Rustling noise from the valve timing gear/VANOS

Variable camshaft adjustment - new version with plate springs since June 1995

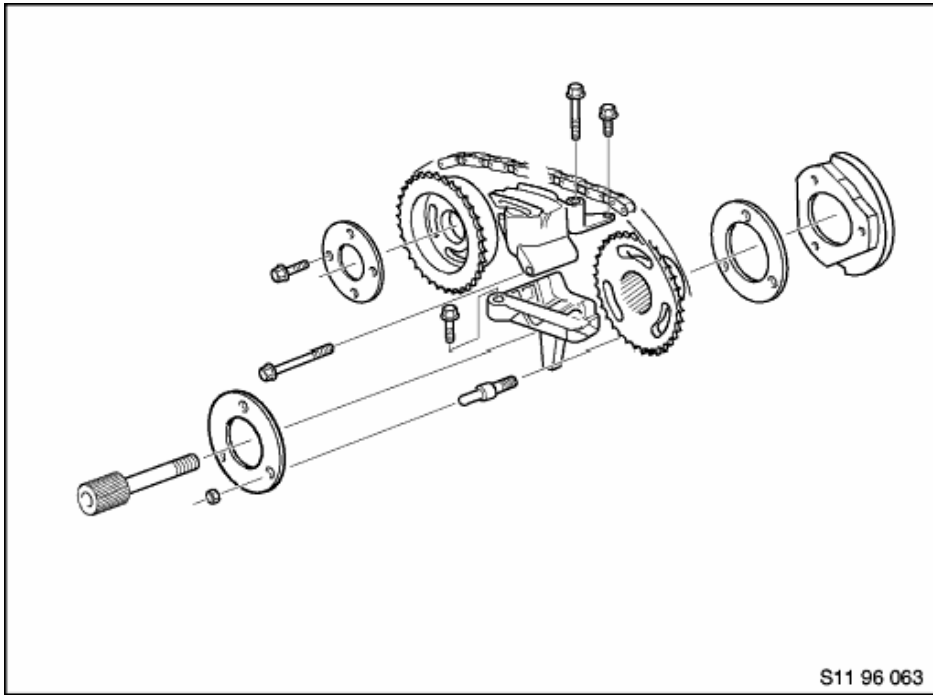
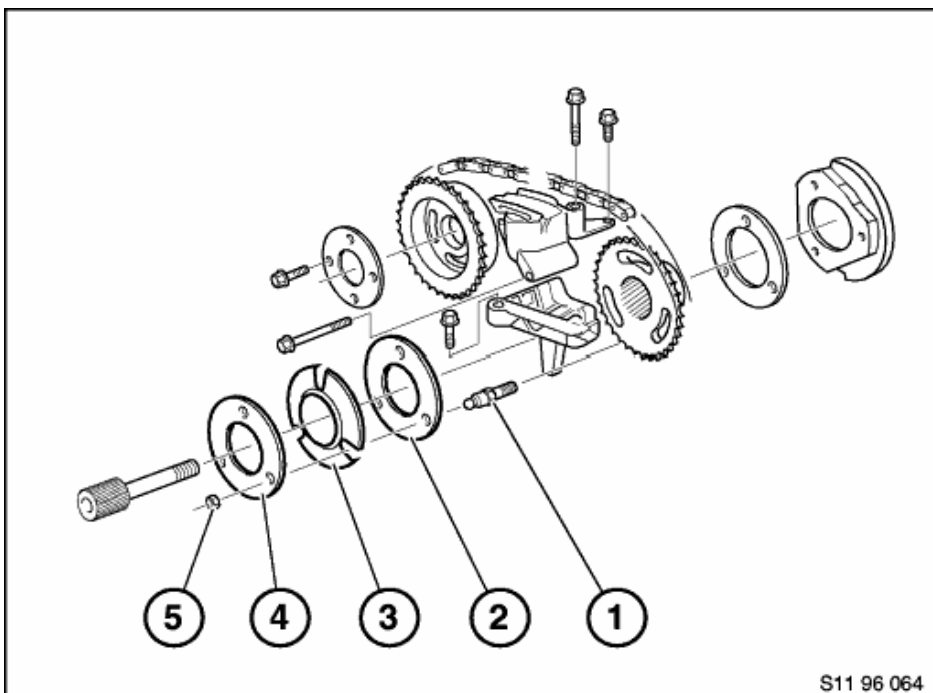
Rustling noises in the area of the timing chain, variable camshaft control (VANOS), camshaft in cold running mode up to an engine speed of 3,000 rpm.

Excessive clearance between the thrust washer and the inlet camshaft sprocket wheel.

Convert the VANOS adjustment unit to plate springs. This solution was introduced to series production in June 1995.

- Remove cylinder head cover.
- Remove VANOS adjustment unit.
See M50 repair instructions - 11 36 010
Please refer to M52 repair instructions - 11 36 010
- Remove inlet camshaft sprocket wheel.
- Install 3 new stud bolts (Fig. 3, item 1).
Application torque: 5 Nm
Joint torque: 22 Nm
- Reinstall sprocket wheel.
- Fit on thrust washer, 2 mm thick (Fig. 3, item 2).
- Fit on plate springs (Fig. 3, item 3). Note installation direction of plate springs: fit with the large support diameter facing the camshaft.
- Fit on thrust washer, 4 mm thick (Fig. 3, item 4).
- Screw on hexagon nuts (Fig. 3, item 5), using Loctite 273 screw locking varnish.
Tightening torque: 10 Nm
- Install VANOS adjustment unit

The plate springs are consciously used to make the camshaft adjustment tighter.
